Name or description of project, LCP, etc.: Appeal No. A-6-COR-08-098 & 099
(Hotel del Coronado, City of
Coronado)

Re: Hotel Del Coronado Response to Staff Report W8a/b
Appeals A-6-COR-08-098 & 99 (Hotel Del Coronado)

Hotel Del Coronado Response to Staff Report W8a/b
Appeals A-6-COR-08-098 & 99 (Hotel Del Coronado)

PARKING LEVEL P2 - REVISED SETBACK

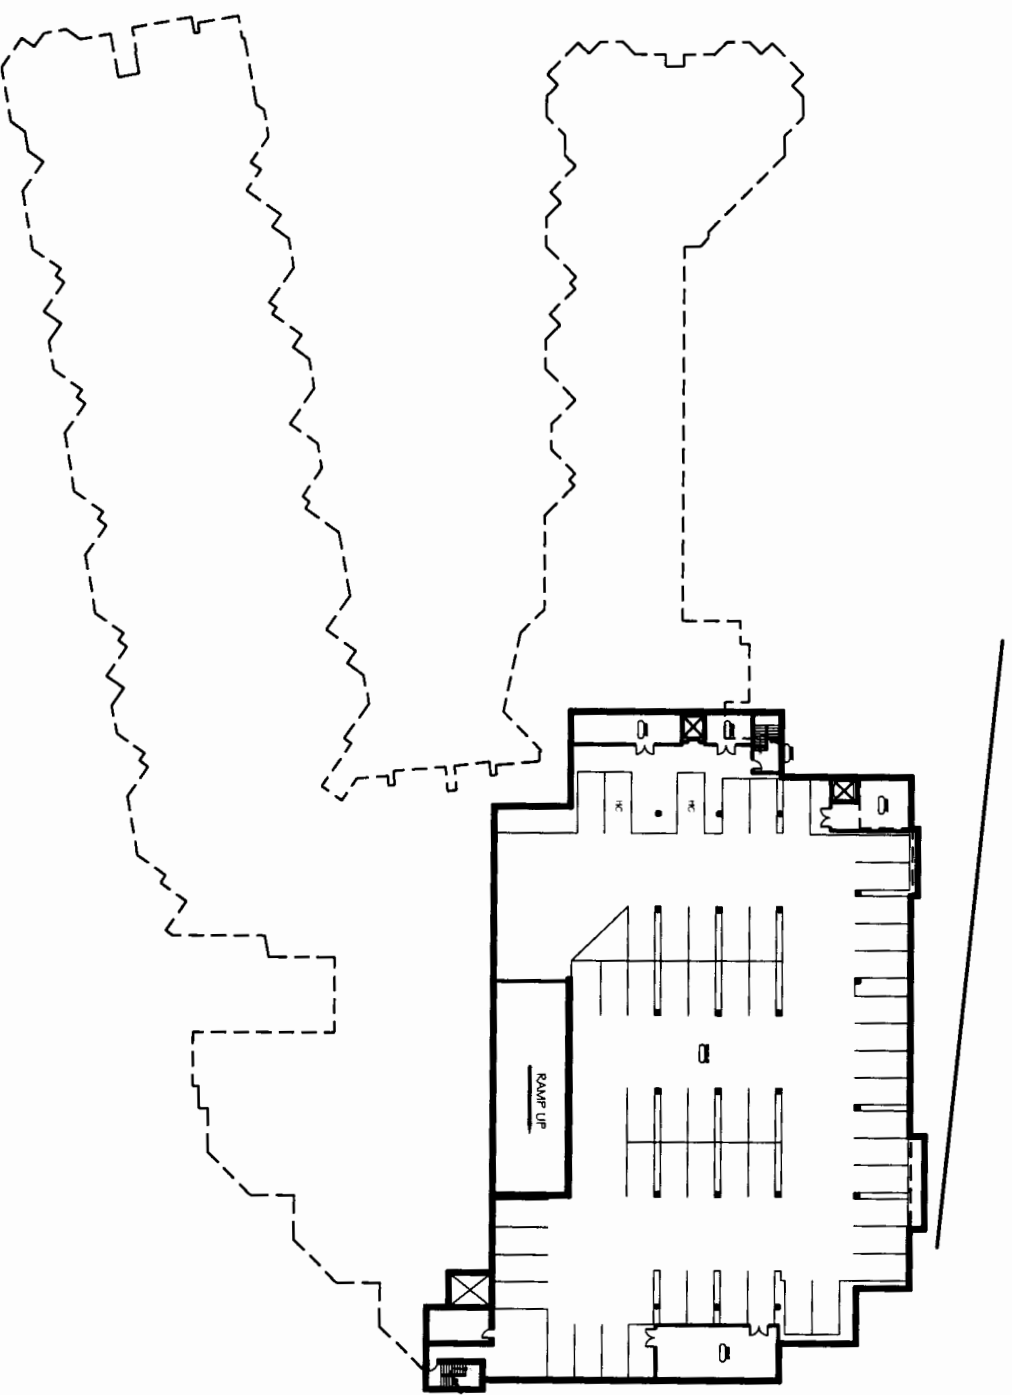
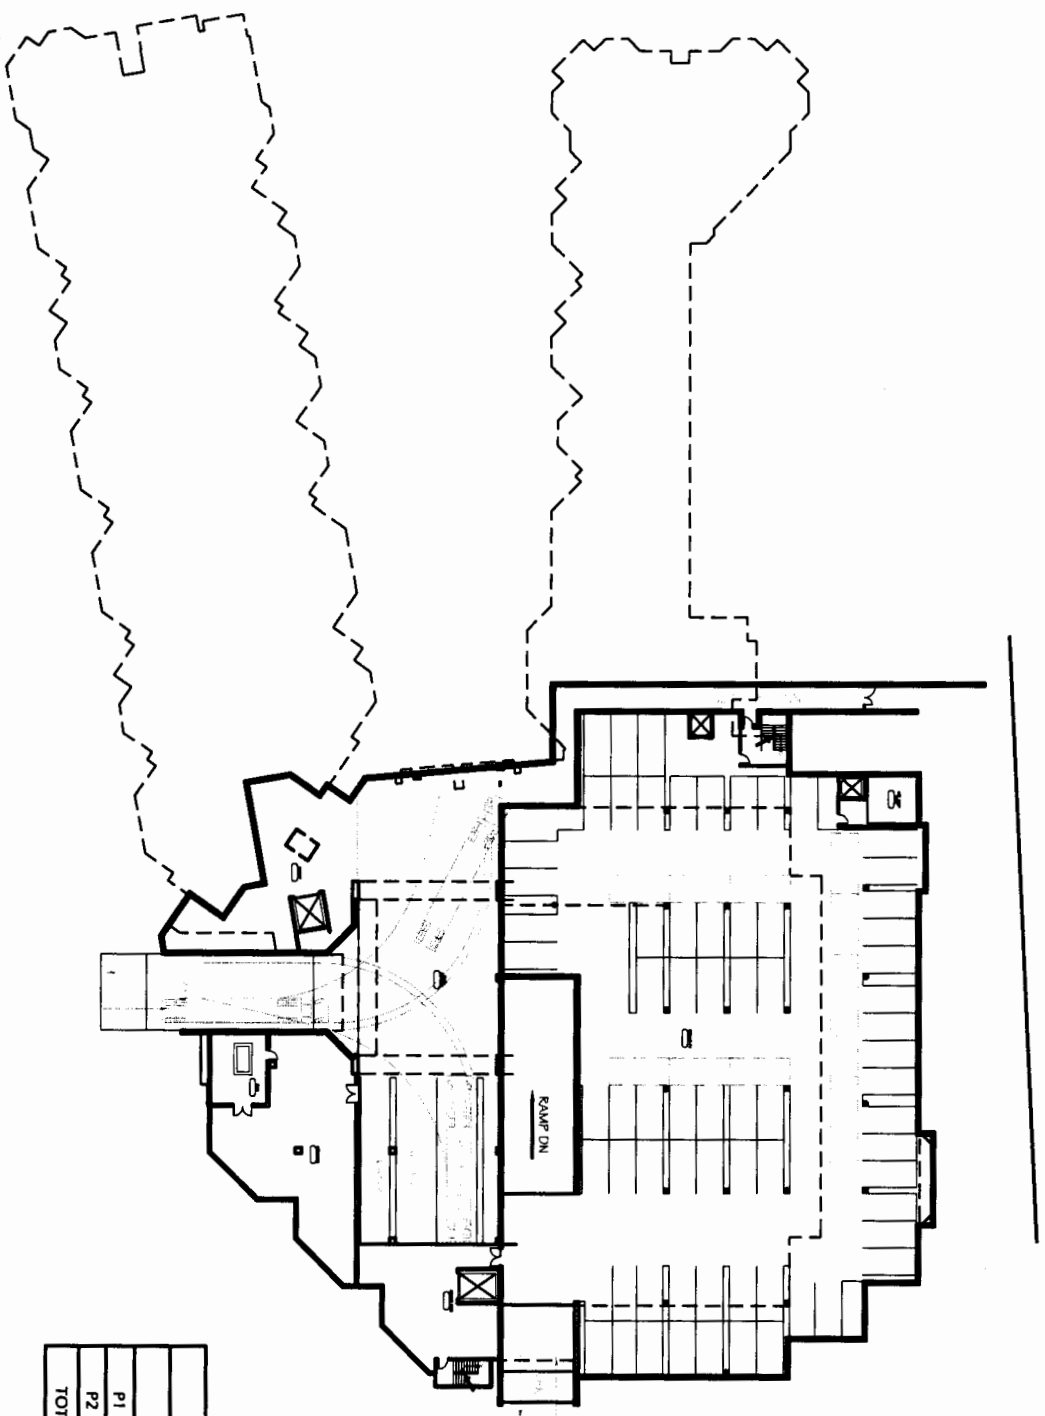
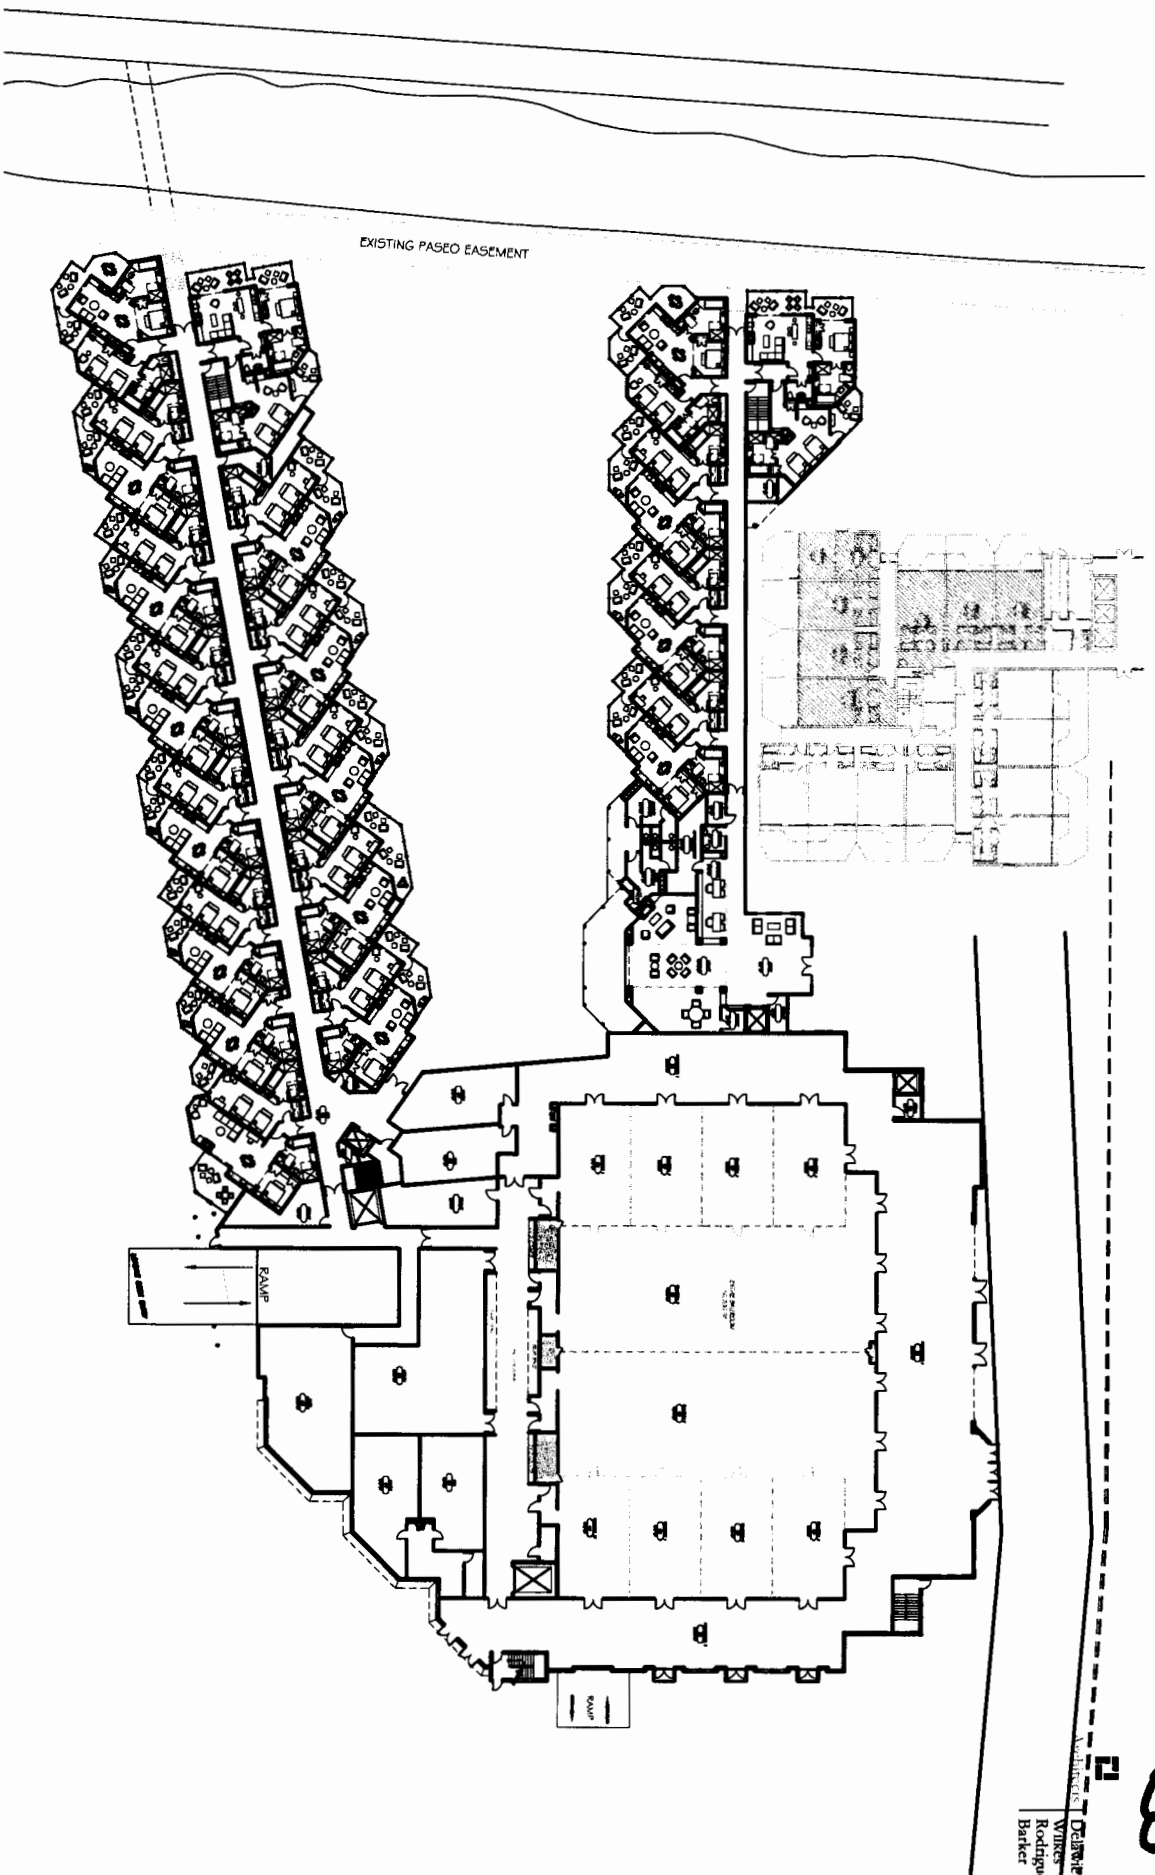
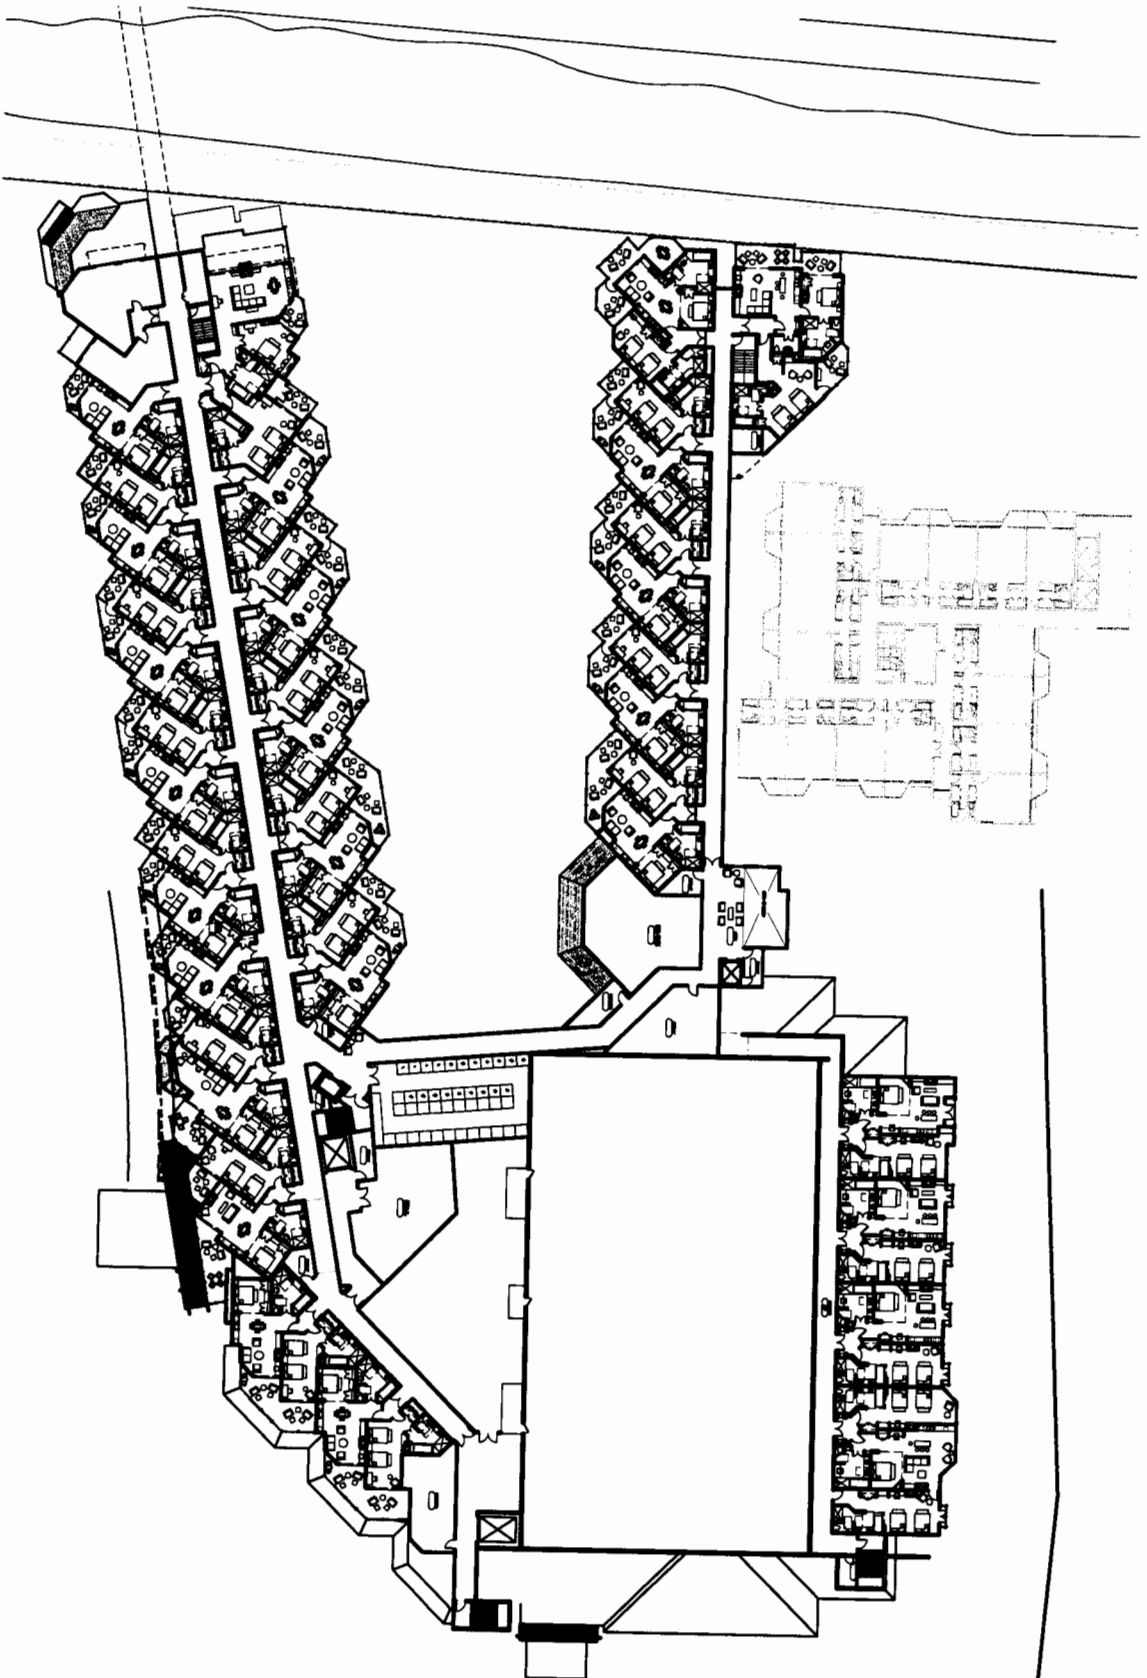
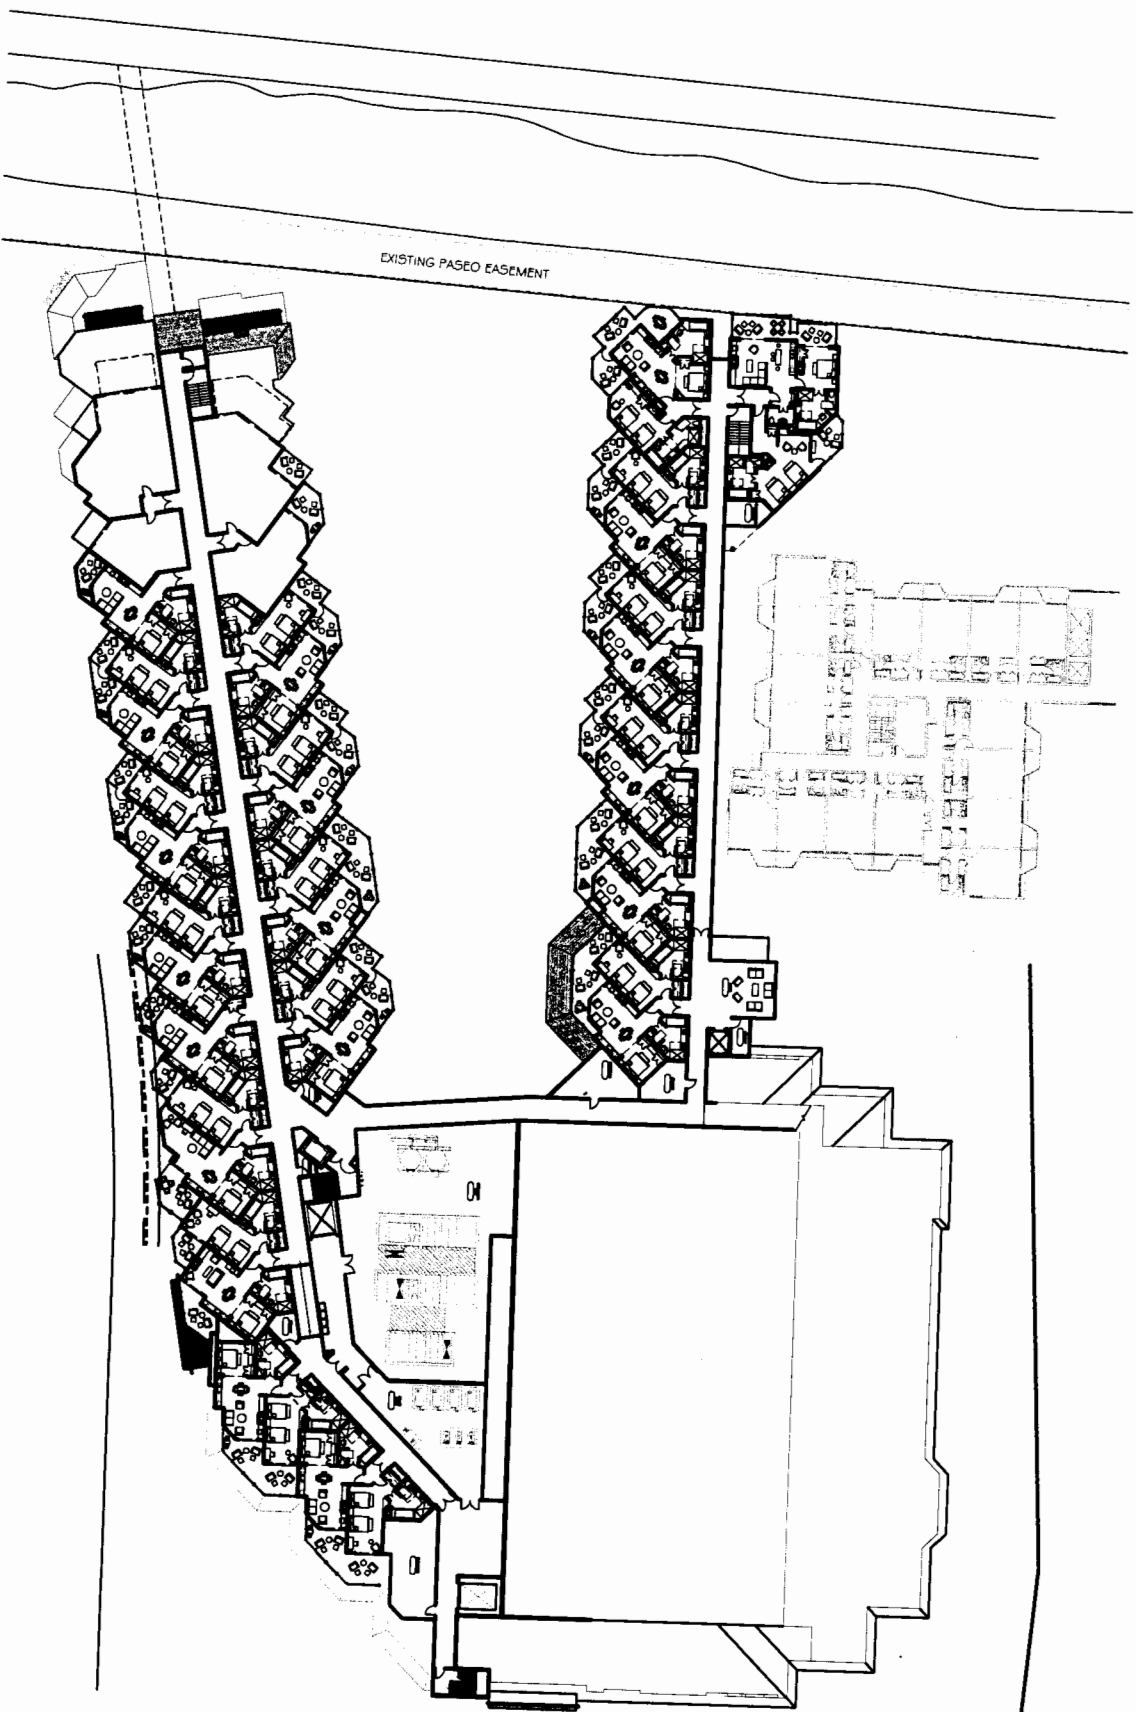
This letter is to summarize the effects to the South Beach Guestroom and Conference Center building due to the proposed 30' increase in the setback from the January 2010 "No Build" zone. Included are physical, or functional, effects as well as programmatic effects. I will comment on how the physical effects of the move can be mitigated or not, but I can't comment on how all of the programmatic effects modify the viability of the project or its proforma.

I will list the modifications made to each level of the floor plan to facilitate the additional setback, and describe the effects of each. Items on each level that are connected have different constraints on some levels and need to be taken into account when a modification is made. Therefore I will summarize the decision making for those elements at the most critical floor.

PARKING STUDY			
	EXISTING SPACES	REVISED SPACES	
P1	82	81	
P2	83	56	
TOTAL	165	137
